**KAWARTHA PINE RIDGE DISTRICT SCHOOL BOARD  
PUR24-057-ITT  
Warsaw Public School Classroom Upgrades**

**ADDENDUM NO. 4**

**END OF ADDENDUM NUMBER NO. 335495.029-01**

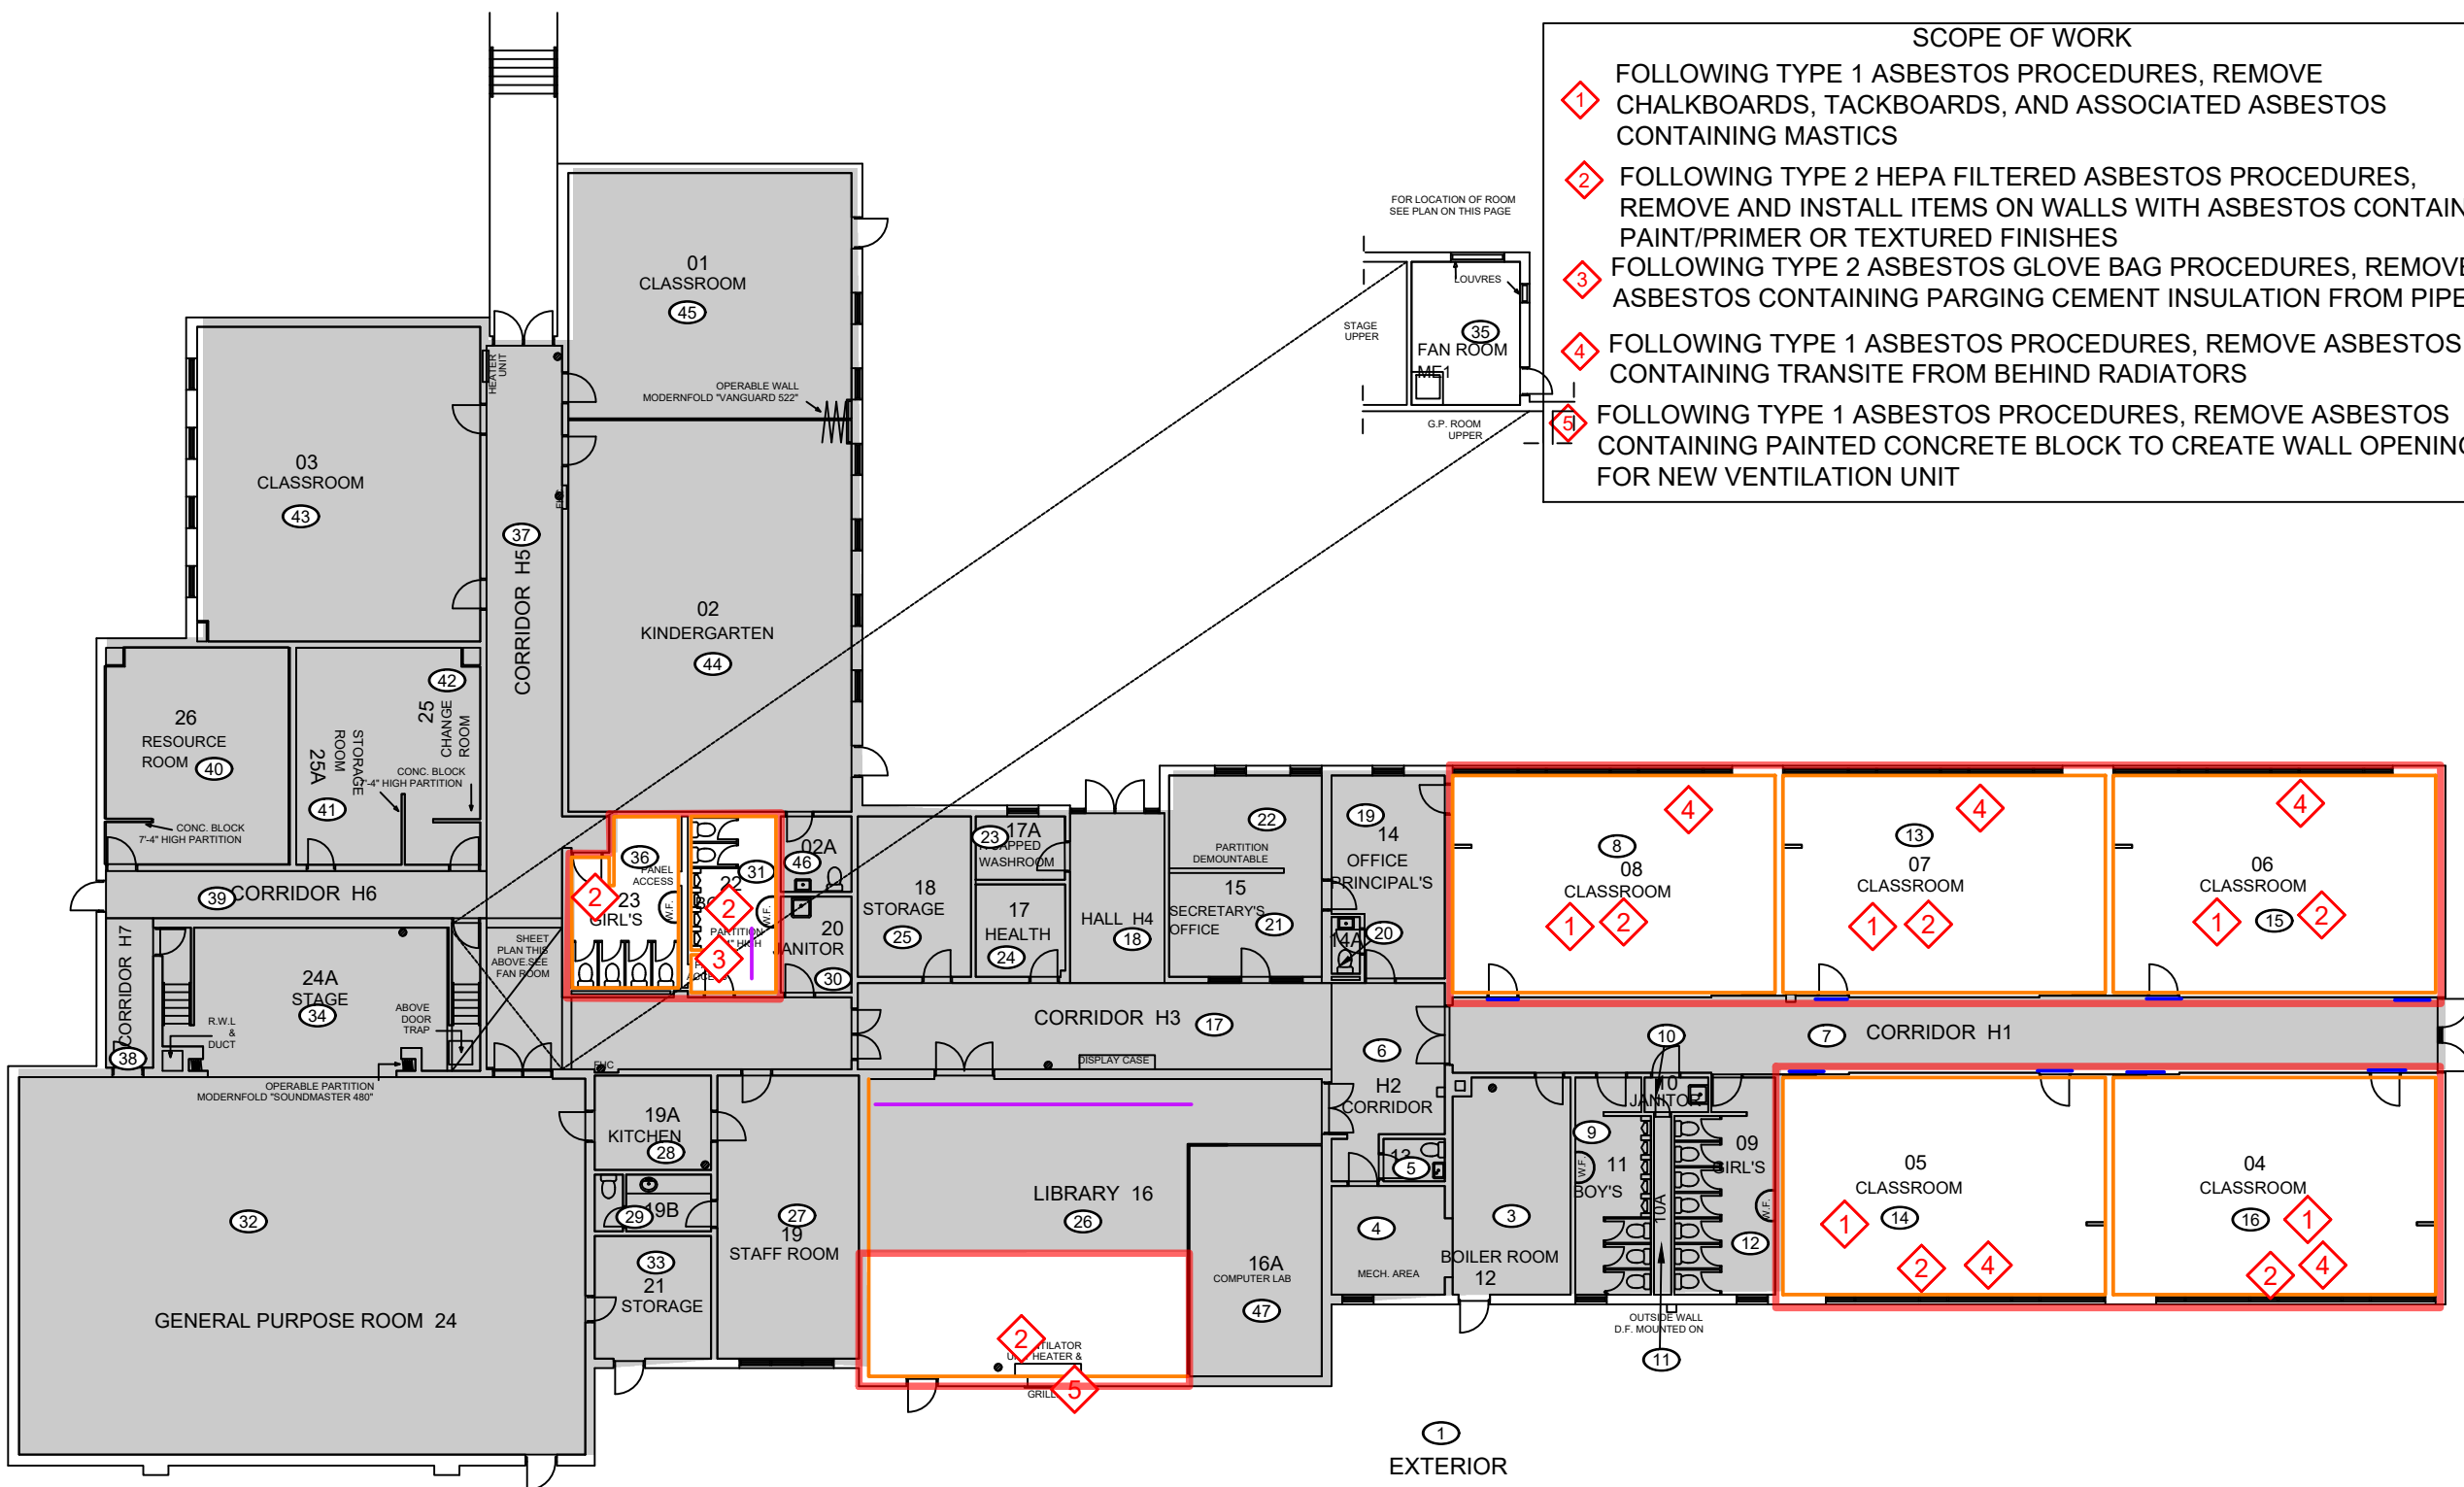
- .1 DRAWING HM-01 – Asbestos Specifications
  - .1 Computer Lab 16A (Location 47) and Work Area (Location 4) have been removed from the work area.
  - .2 Notation for removal of painted concrete block added to Library 16 (Location 26).
